## Addendum #3

Date: April 13, 2018  
To: All Bidders and others to whom Plans & Specifications have been issued  
From: Kil Architecture/ Planning  
Gregory A. Kil, AIA, NCARB  
Architect  
RE: **Remodeling Interfaith Apartments North Building  
Interfaith Housing Corporation  
34 Northwest 5<sup>th</sup> Street  
Richmond, IN 47374**

DETAIL 1 @ PTAC & LATERAL TRANSFER DUCT  
 PARTIAL DRAWING A4.1

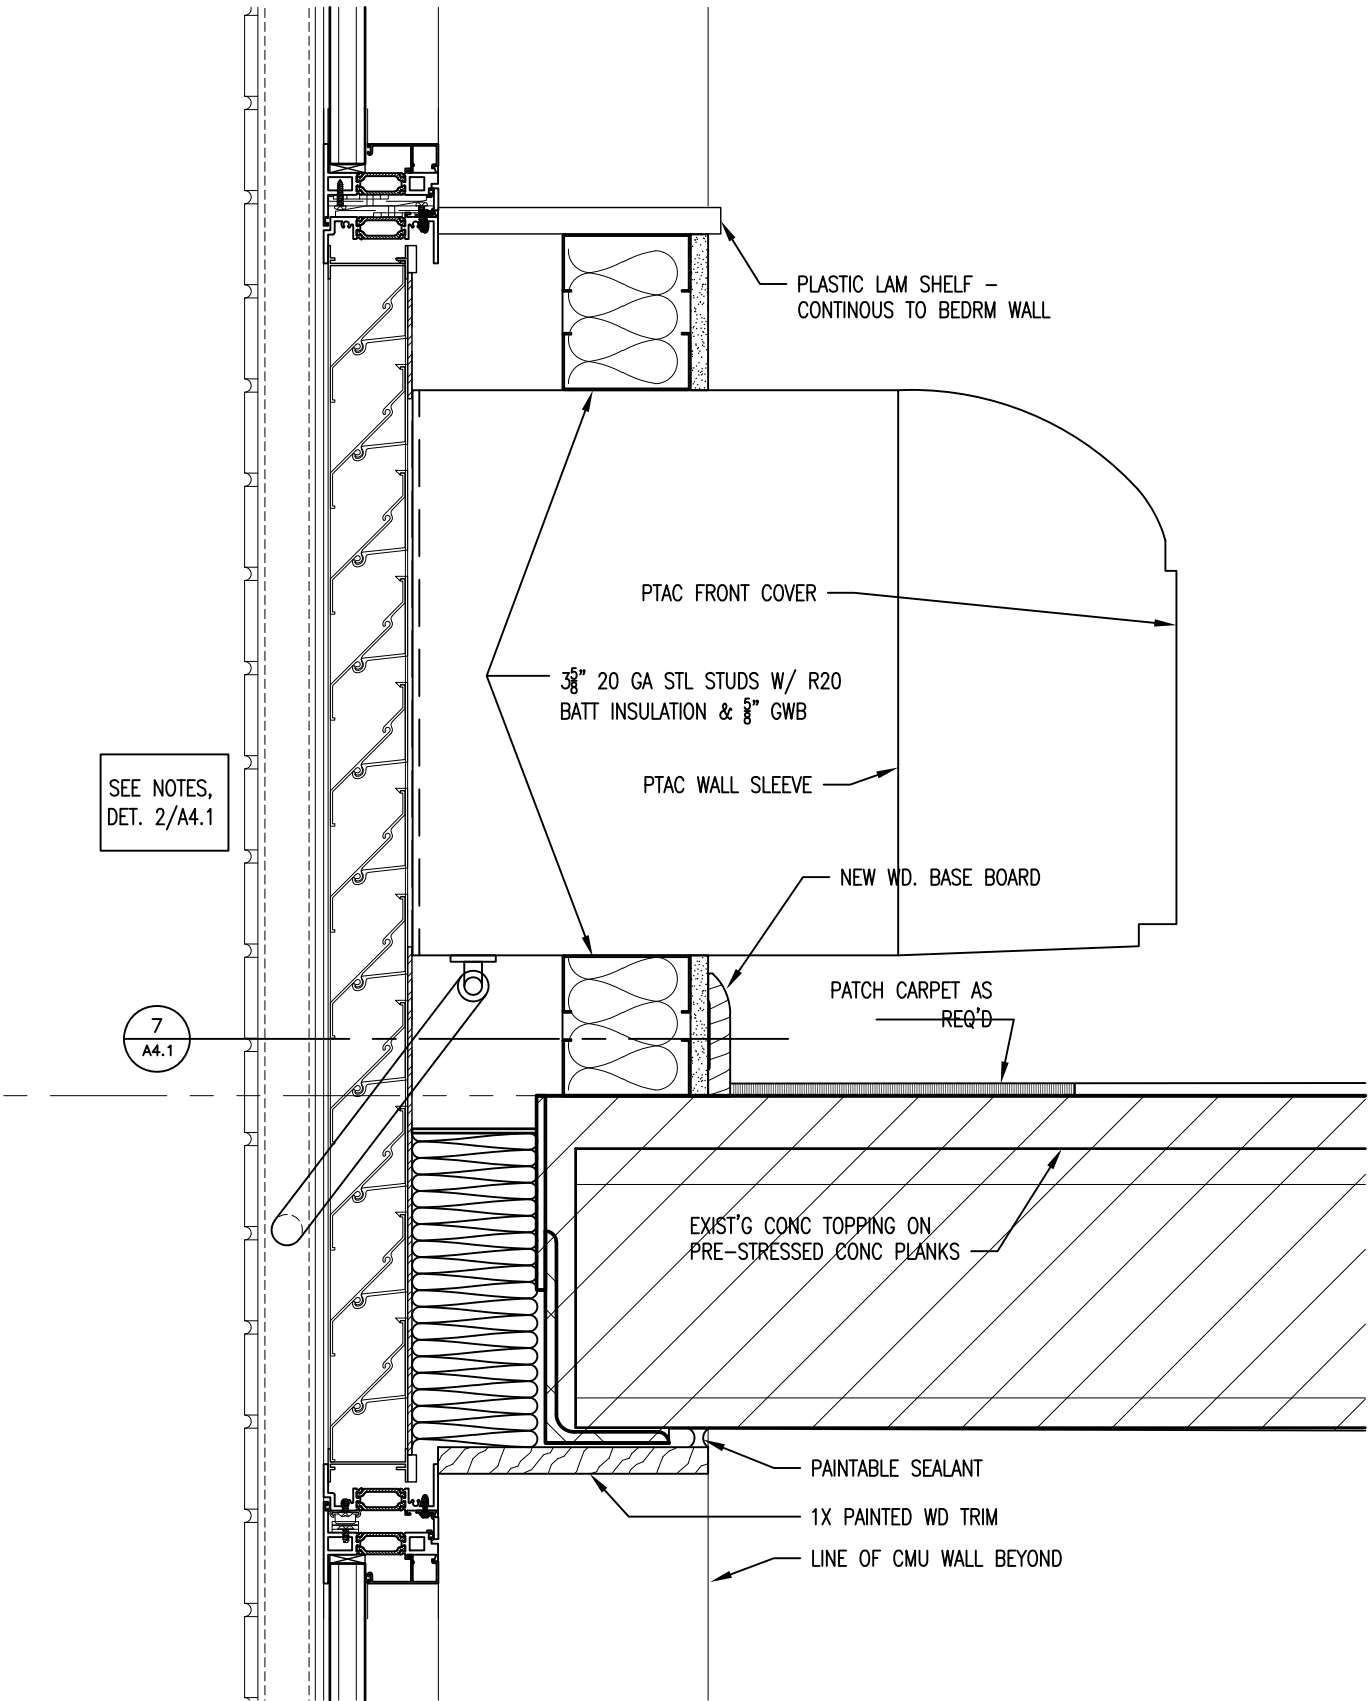
1. Revise Detail 1 in accordance with attached drawing ADD-28.
2. Revise Detail 2 in accordance with attached drawing ADD-29.
3. Detail 3, Window Elevation Detail:
  - a. Clarification: **Vertical dimensions of windows, spandrels and louvers shall be coordinated with height and installation details of PTAC unit components. All dimensions shall be field verified by Contractor. New window system shall completely fill masonry openings.**
4. Revise Detail 4 as follows:
  - a. **Revise firestopping at edge of floor slab to match Detail 1/A4.1.**
5. Revise Details 6 and 7 in accordance with attached drawing ADD-30.

JAMB DETAILS 6 & 7  
PARTIAL DRAWING A4.1

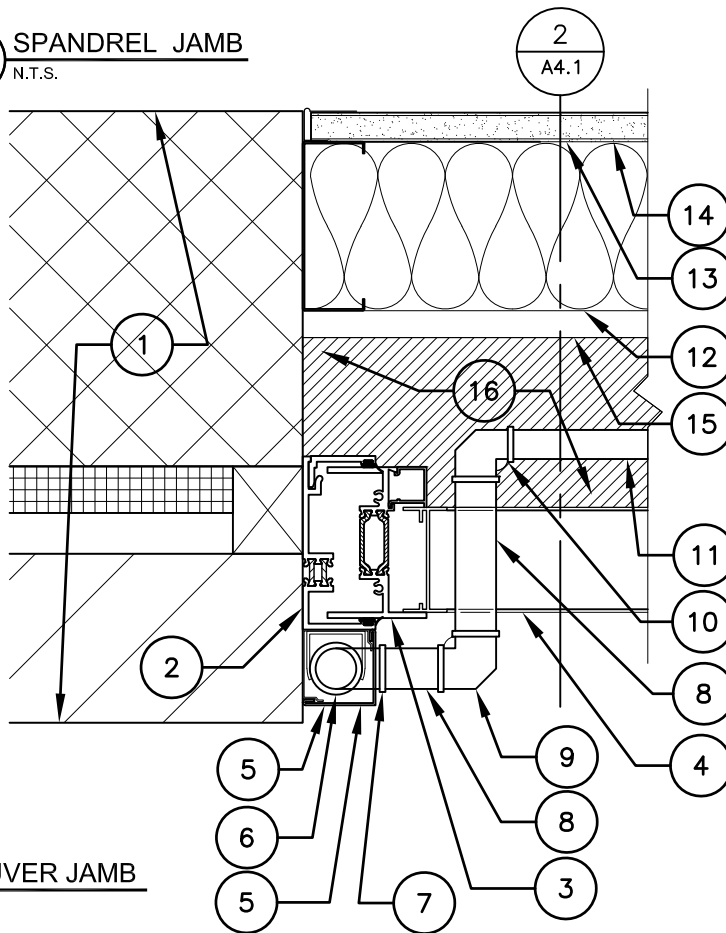
1. Detail 4/A4.4: **Key in detail 6/A4.1 at the left window jamb and detail 7/A4.1 at the right window jamb.**
2. Detail 5/A4.4: **Key in detail 6/A4.1 at the left window jamb and detail 7/A4.1 at the right window jamb.**

MEP ENLARGED  
PLANS

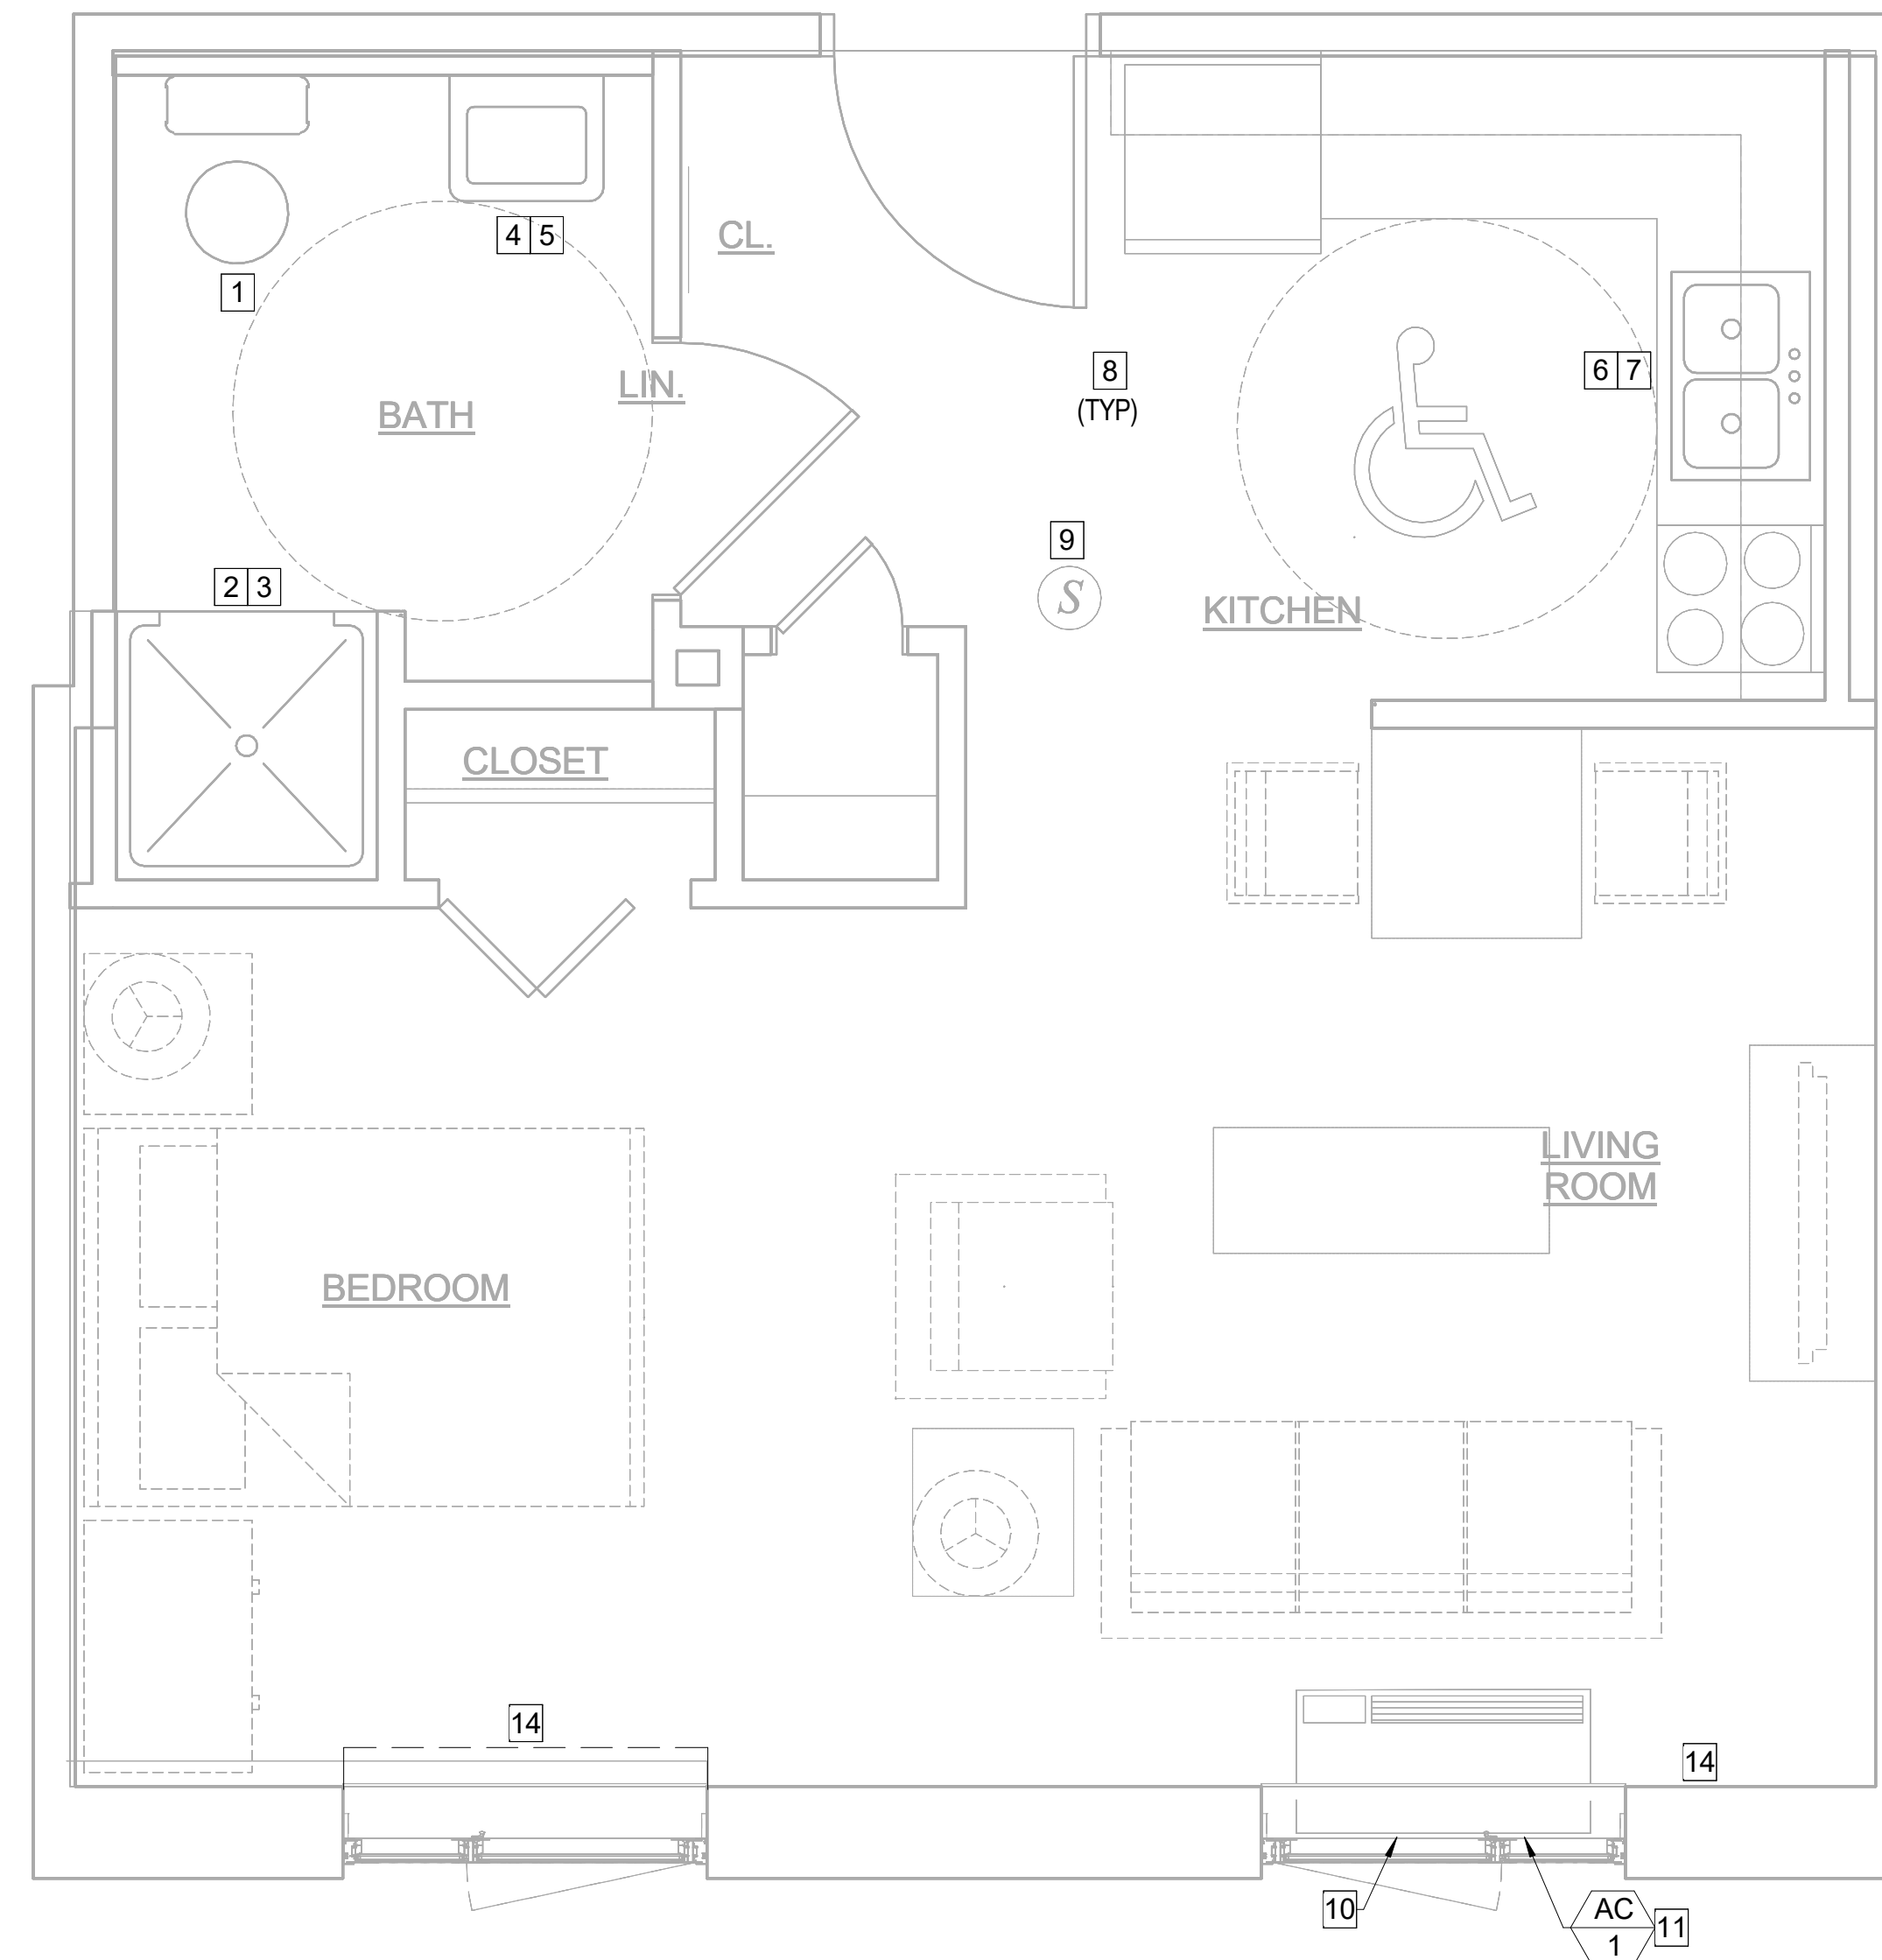
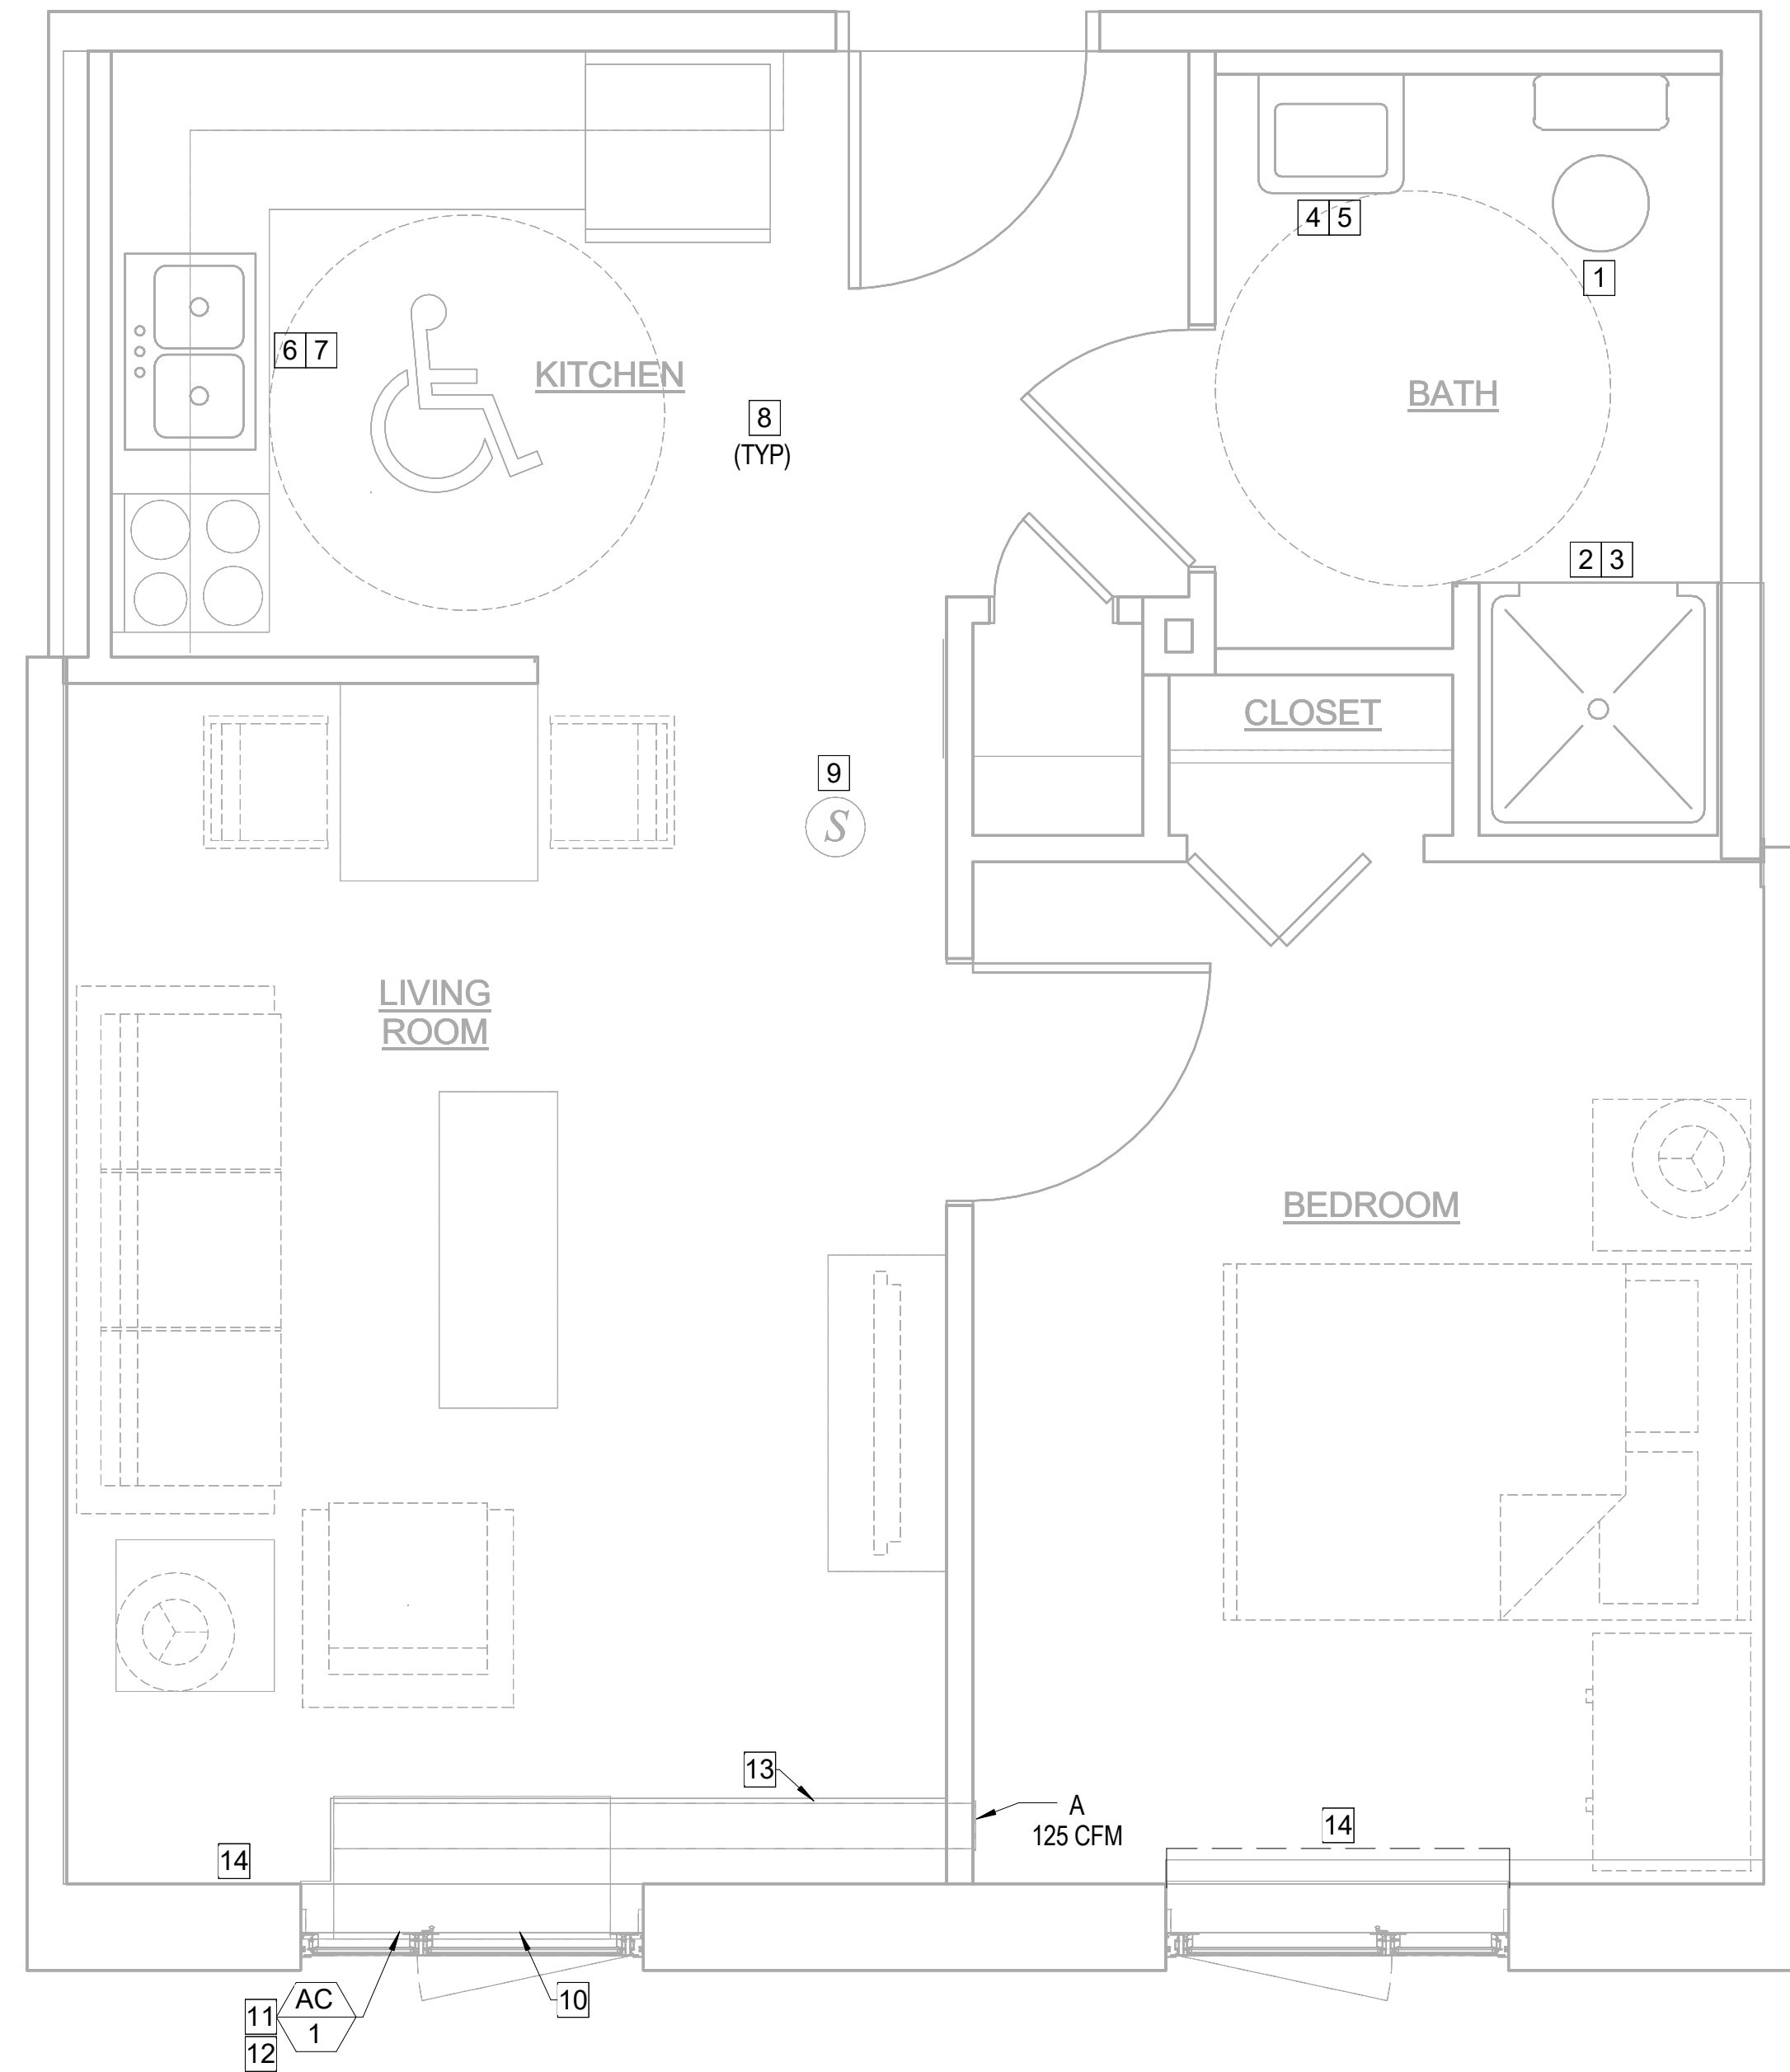
1. **Add new sheet MEP1.9 in accordance with attached drawing MEP1.9.**
